Technical Memo

A Review of Renewable Resource Economics in Puget Sound Energy's Draft Clean Energy Implementation Plan

Figure 1. PSE Forecasted wind LCOEs (COD 2025) compared to historical wind LCOEs. [Historical data source: 2021 Land-based Wind Market Report, LBNL]

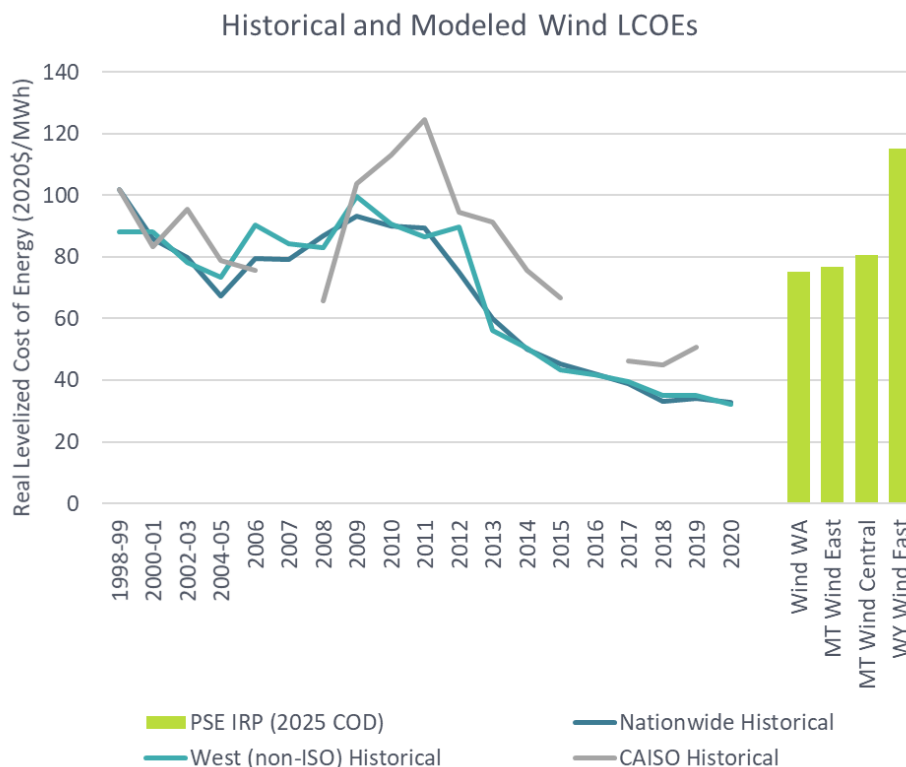
Our review found that the wind resource costs reported in PSE's IRP and used in the CEIP are significantly higher than recent market experience and could be leading to poor outcomes for customers in PSE's plans. **Figure 1** compares PSE's wind resource costs to historical average wind levelized costs of energy (LCOEs) as reported in the U.S Department of Energy's 2021 Land-based Wind Market Report.¹ PSE's lowest cost wind resource in 2025 (WA Wind at \$75/MWh²) is 48% more expensive than the most recently reported wind costs in California (\$51/MWh) and 130% more expensive than the 2020 nationwide average (\$33/MWh).

Figure 2. Cost/benefit comparison for 2025 WA Wind with and without the SCGHG

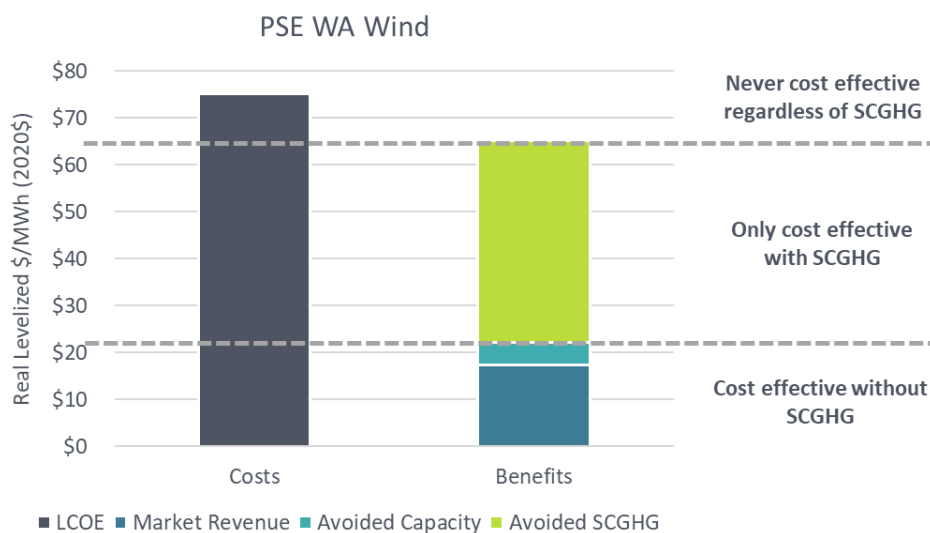
Figure 2 shows this comparison for a WA Wind resource based on information in PSE's 2021 IRP. In this analysis, we assume that emissions are avoided at the market emissions rate and we assume an ELCC of 15.1% and a cost of capacity of \$148/kW-yr based on information in the IRP. In order for PSE's WA Wind resource to be more cost effective than the alternatives (i.e., energy purchased from the market and the equivalent amount of capacity provided from a peaker plant), the benefits must exceed the costs.

The figure shows three different regimes for the impact of the SCGHG on cost effectiveness depending on the resource cost. In this example, if the WA Wind resource costs less than \$22/MWh, it is cost effective regardless of whether there is a SCGHG and if it costs more than \$65/MWh, it is not cost effective regardless of whether there is a SCGHG. Between these two cost thresholds (\$22/MWh and \$65/MWh), the resource is cost effective in part due to the SCGHG, so the amount of the resource that is selected should be affected by the SCGHG. In this regime, the SCGHG sends a strong economic signal to procure WA Wind.

As shown in the figure, PSE's WA Wind resource costs are so high that the SCGHG does not impact whether or how much WA Wind is selected in portfolio optimization even if it is fully accounted for. Because other renewable resources in PSE's IRP are even more expensive than WA Wind, the SCGHG does not provide a meaningful signal to invest in renewable resources over pursuing emitting alternatives. This is consistent with PSE's contention that it is the CETA constraint that drives renewable resource acquisition in the IRP and the CEIP, not the SCGHG. What is problematic about this assertion is that it appears to hang on PSE's exceptionally high resource cost assumptions. If we update resource costs in the manner described in the previous section, WA Wind costs appear to fall below the threshold at which the SCGHG begins to influence resource selection (**Figure 3**).

Figure 3. Cost/benefit comparison for 2025 WA Wind with and without the SCGHG with resource cost updates

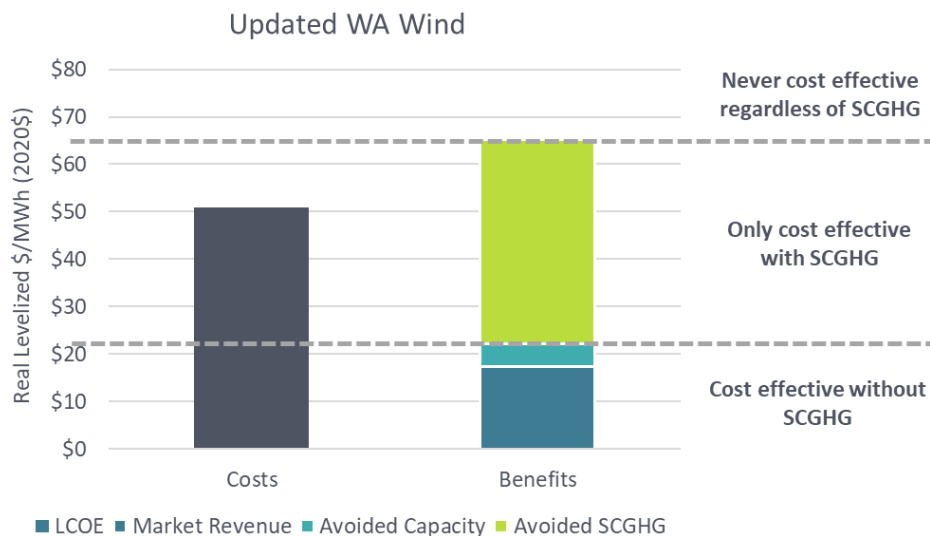
This suggests an important relationship between resource cost and sensitivity to SCGHG modeling, which we explore further below. While it may be true that the SCGHG methodology is not a significant driver of portfolio composition with PSE’s current assumptions, we do not know if this finding would persist if lower resource costs were tested.

Figure 4. Illustrative optimal renewable selections with various SCGHG treatments, under high and lower renewable cost assumptions

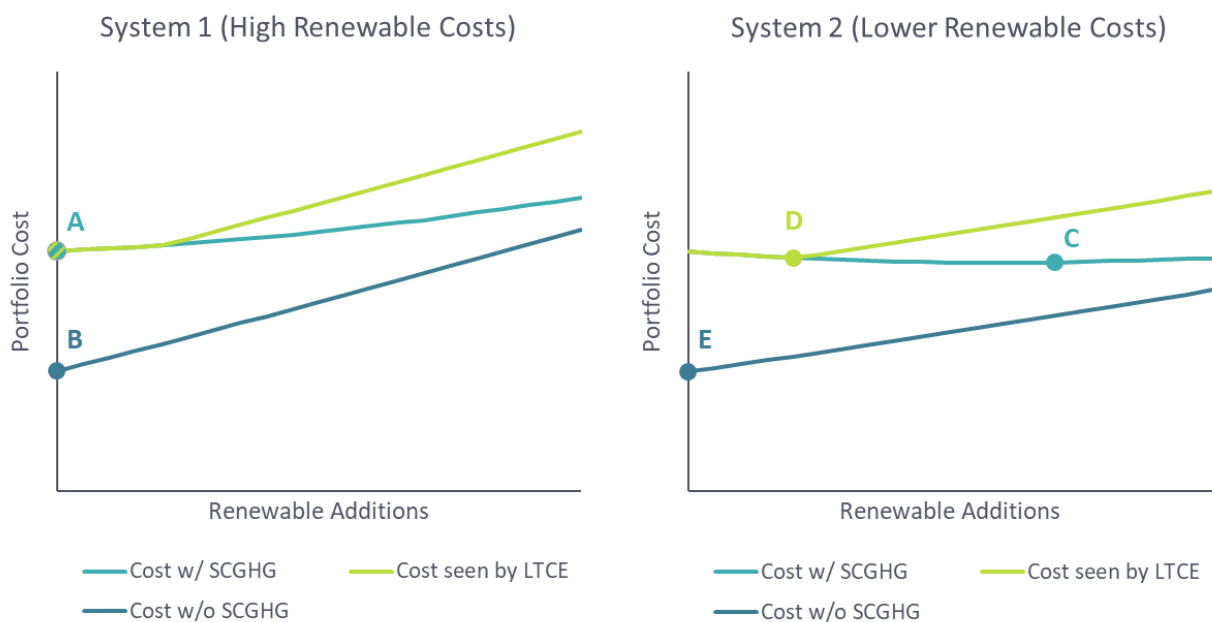
To illustrate how changing resource costs might impact the sensitivity of portfolios to the SCGHG and SCGHG methodology, we compare two hypothetical systems. In the first, renewable resource costs are so high that they are never cost effective regardless of the SCGHG. The left panel of Figure 4 shows portfolio costs for this system (System 1) under various SCGHG treatments as more renewable energy is added. The dark blue line shows portfolio costs without the SCGHG; the turquoise line with the SCGHG, assuming that renewables can avoid market purchases and displace thermal generation; and the lime green line with the SCGHG, but assuming that renewables can only avoid market purchases and cannot affect thermal GHG emissions (as is assumed in PSE’s LTCE optimization model). In all three cases in System 1, the net impact of adding more renewables is to increase portfolio costs because the renewable costs are strictly higher than resource benefits. In this system, the economically optimal amount of renewable additions is zero in all cases (points A and B) and renewables will only be selected to the extent that they are required in order to meet a CETA constraint, regardless of the SCGHG methodology. This appears to be the case with PSE’s CEIP modeling.

Now consider a second system (System 2 in the right panel of **Figure 4**) where renewable resource costs are low enough that the SCGHG affects whether they are selected. In this system, the dark blue line is still increasing, though not as steeply because adding renewables does not increase costs as much as in the first system. In this system as well the first, without the SCGHG, the economically optimal amount of renewable additions is zero (point E) and renewables will only be selected if they are required to be. However, we see different results when we account for the SCGHG. Both curves that account for the SCGHG begin with a negative slope – that is, for small additions, benefits outweigh costs. If both the ability to reduce market purchases and displace thermal dispatch are accounted for (turquoise line), then declining marginal benefits lead to a point of economic equilibrium, where the costs of incremental renewables exactly equal their benefits and total portfolio costs are minimized (point C). Without any constraints, this is the economically optimal amount of renewable energy that would be added to the system – this is the amount that should be identified in the No-CETA portfolio and should not be attributed to CETA in the incremental cost calculation. If this amount is less than the amount required by the CETA constraint, then the CETA constraint will still determine the total amount of renewable energy added and there will be non-zero incremental costs associated with procuring the resources that go beyond the economically optimal point. However, if the economically optimal point is greater than the amount required by the CETA constraint, then CETA will not determine the amount of renewables added and the incremental cost associated with renewable additions will be zero.

Now let's examine the lime green line in System 2, which illustrates what PSE's LTCE model might see when it is forming optimal portfolios. Initially, the lime green line follows the turquoise line because renewable additions simply avoid market purchases, a SCGHG benefit that can be seen by the LTCE. But at some point, continued emissions reductions are achieved by reducing thermal dispatch, which the LTCE cannot see. At this point, the two curves diverge – the actual emissions and associated portfolio costs continue to drop, but the costs seen by the LTCE model rise as if there are no further emissions

reductions. From the perspective of the LTCE model, this point where the curves diverge (point D) appears to be economically optimal – it achieves the lowest portfolio cost as seen by the LTCE model. But this point is far from the true economically optimal point – it is merely an artifact of PSE’s fixed SCGHG assumption. While it is true that the lime green line is an overestimation of the SCGHG, as PSE acknowledges, optimizing to that line actually results in an underestimation of the optimal amount of renewables.

Figure 5. Illustrative optimal renewable selections with various SCGHG treatments (System 2 zoomed out)

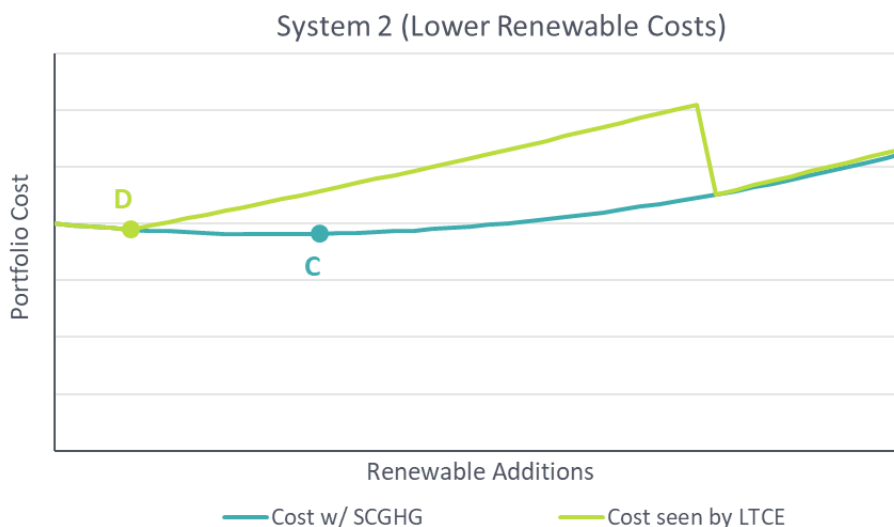
At a high level, if PSE were to update resource costs in the manner described in this report and rerun their models, we might expect the No-CETA portfolio (Scenario S) to sit at point D, when it should actually sit at point C. By underestimating the amount of renewables that are economically optimal, PSE’s methodology could result in an overestimation of the portion of the renewable costs attributable to CETA, even with updated resource costs. To identify whether this might be happening, PSE should run

the same tests that they ran in the IRP with respect to the SCGHG methodology. Specifically, PSE should test the No-CETA portfolio with the SCGHG treatments used in Scenario I and Scenario J of the IRP.
